1064035 PB84-195577 84-0038 Review of the Swedish KBS-3 Plan for Final Storage of Spent Nuclear Fuel

A Review of the Swedish KBS-3 Plan for Final Storage of Spent Nuclear Fuel

Panel for the Review of the Swedish KBS-3 Plan Board on Radioactive Waste Management Commission on Physical Sciences, Mathematics, and Resources National Research Council

FIGURE 4-1 Calculation sequences in KBS-3.

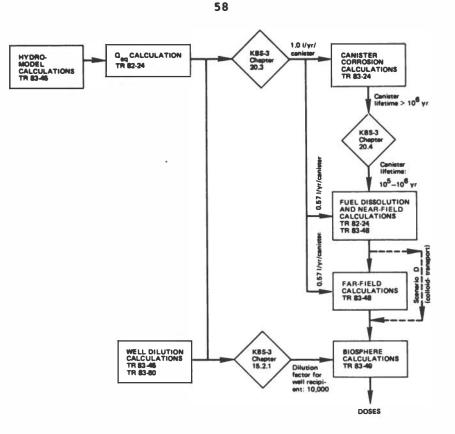
In response to the panel's request for clarification, Tönis Papp (KBS, private communication, 1983) provided a calculation scheme specifying the model used at each step of the safety evaluation, as well as the points at which judgmental factors influenced the input data. That diagram is reproduced here (Figure 4-1) as a description of the panel's understanding of the actual sequence of calculations and data input used for the KBS-3 safety analysis for the well recipient. In the diagram, model calculations or analytic solutions are represented by rectangles with the appropriate supporting report referenced, whereas each rhombus represents a judgmental decision for which an explanation can be found in the referenced KBS-3 chapter, and input-output data are represented by arrows.

As shown on Papp's diagram, the "hydromodel" of TR 83-45 is used to obtain an estimate of flux, $U_{0,r}$ through the bedrock surrounding a repository. The single-value output from the hydromodel is used directly as input to the near and far-field calculations (TR 82-24, TR 83-48) to obtain an estimate of the equivalent water flow past each canister, Q_{eq} . Although the Canister Corrosion calculations indicate canister breaching will not occur before 10⁶ years and perhaps not until 10⁸ years, the KBS authors pessimistically assume as input to the calculation of Fuel Dissolution that canister failure will begin at 10⁵ years with the last canister failing at 10⁶ years. As noted in the section in Chapter 4 entitled "Retardation in the Far-Field," evaluation of dilution factors for the well recipient ranging from a worst-case value of 10^2 (TR 83-50) to a highly optimistic value of 10^7 (TR 83-45) led to selection (rhombus indicating KBS-3, Chapter 15.2.1) of a dilution factor of 10,000 as input to

Biosphere Calculations (TR 83-49) in combination with output from Far-Field Calculations. The safety analysis for a lake recipient is performed in an analogous manner, except for substitution of turnover rates in Morpa Lake (TR 83-52) to estimate a dilution factor for the lake recipient (KBS-3, Chapter 18.2.5).
